UNITED STATES PATENT AND TRADEMARK OFFICE

APPLICATION NO.	FILING DATE	FIRST NAMED INVENTOR	ATTORNEY DOCKET NO.	CONFIRMATION NO.
10/579,852	05/17/2006	Dietmar Van Der Linden	R.307220	8908

Office Action Summary	Application No. 10/579,852	Applicant(s) VAN DER LINDEN ET AL.	
	Examiner WILLIAM MCCALISTER	Art Unit 3753

DETAILED ACTION

Fig. 5

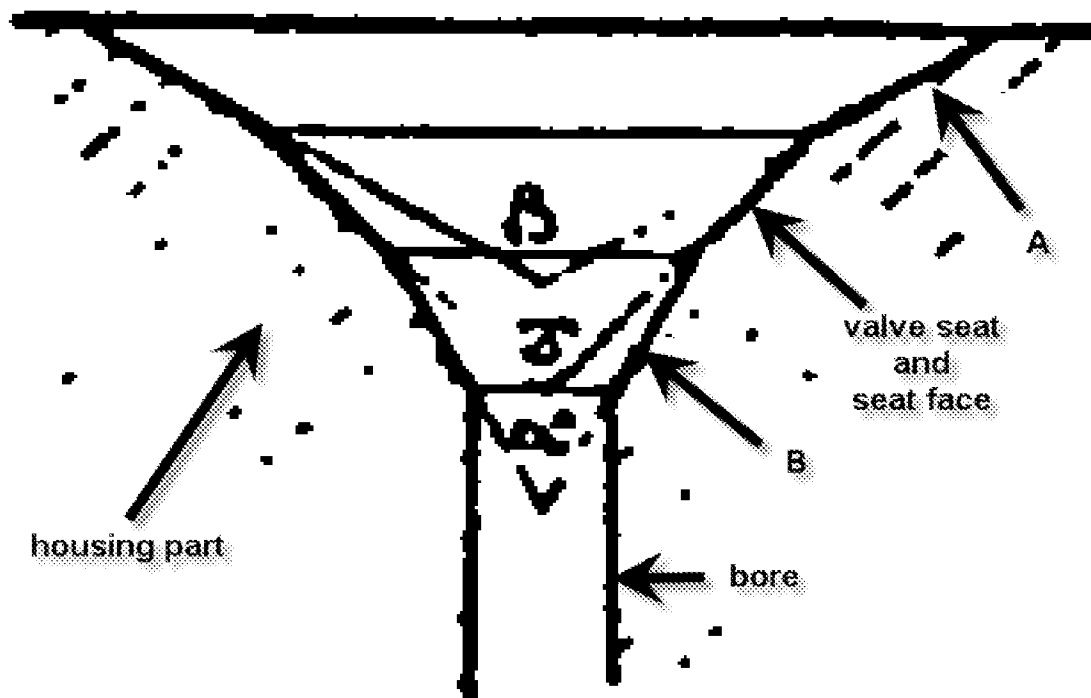
Regarding claims 8 and 10, Citroën discloses, in a valve for a high-pressure pump of a fuel injection system for an internal combustion engine (intended use met by Citroën's capability of being so used), the valve having a valve member (the "movable organ", as translated) which cooperates with a valve seat (see annotated close-up of FIG 5 below, in light of p. 1, ¶13 of the translation) formed in a housing part (see annotated FIG 5) on which seat the valve member rests when the valve is closed (inherently; it's a valve seat) in order to close a bore through the housing part (see annotated FIG 5), the valve seat having an at least approximately conical seat face which is located at a transition of the bore from a portion of small diameter to a portion of large diameter, the seat face forming an acute angle with the longitudinal axis of the bore (as understood), the improvement:

wherein the seat face, on its side oriented toward the portion of large diameter, is adjoined by at least one face ("A" of annotated FIG 5) which forms a larger acute angle with the longitudinal axis of the bore than the seat face (as understood), and

wherein the seat face, on its side oriented toward the portion of small diameter, is adjoined by at least one face ("B" of annotated FIG 5) which forms a smaller acute angle with the longitudinal axis of the bore than the seat face (as understood).

Citroën does not disclose an additional face which forms the largest acute angle, or an additional face which forms the smallest acute angle with the axis of the bore (as understood). However, it would have been obvious to one of ordinary skill in the art at the time of invention to provide two additional inclined faces, since mere duplication of the essential working parts of a device (i.e., adding more inclined faces) is generally seen as involving only routine skill in the art.
